AMENDMENTS TO ADDRESS RFI 0796 DATED 15th JUNE 2012

PROJECT
ADAMSTOWN STATION BLOCK G

DRAWING
GENERAL ARRANGEMENT - LEVEL 01 - FIRST FLOOR PLAN

STATUS CODE: DRAWING NUMBER
ADC-HJL-G-01-DR-A-1011

GA - 01 - FIRST FLOOR
1 : 200

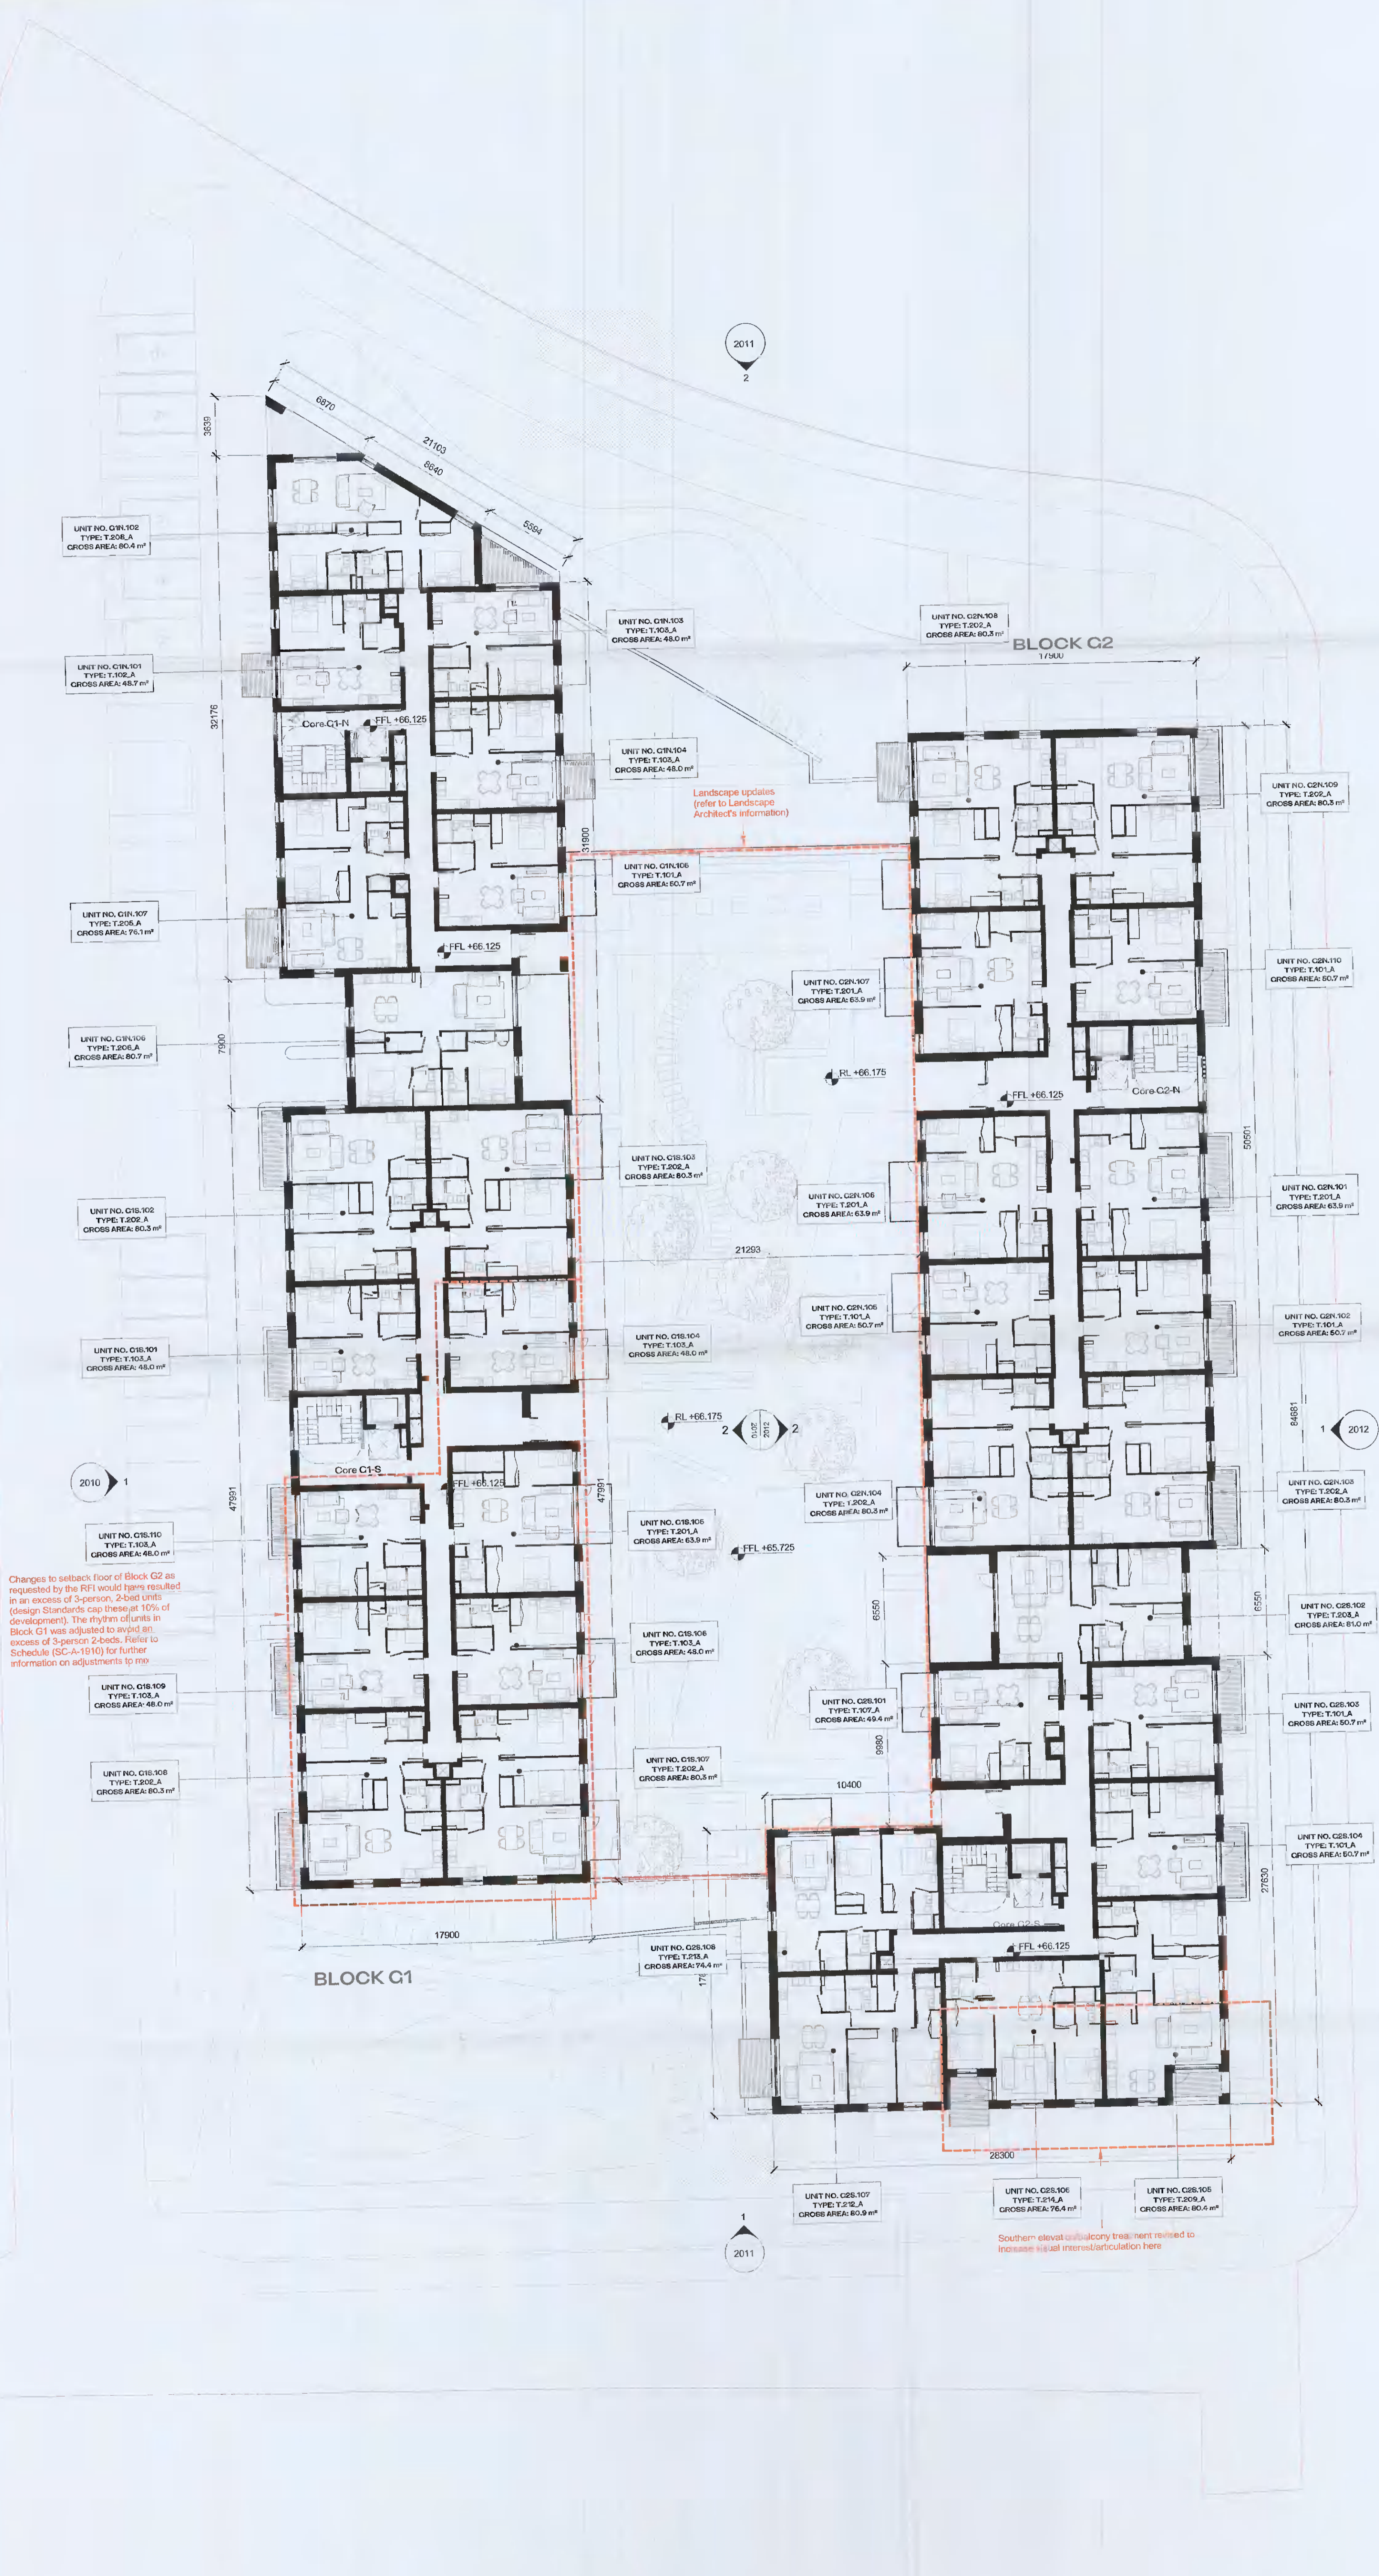
Changes to setback floor of Block C2 as requested by the RFI would have resulted in an excess of 3-person, 2-bed units (design Standards cap these at 10% of development). The rhythm of units in Block G1 was adjusted to avoid an excess of 3-person 2-beds. Refer to Schedule (SC-A-1910) for further information on adjustments to mo
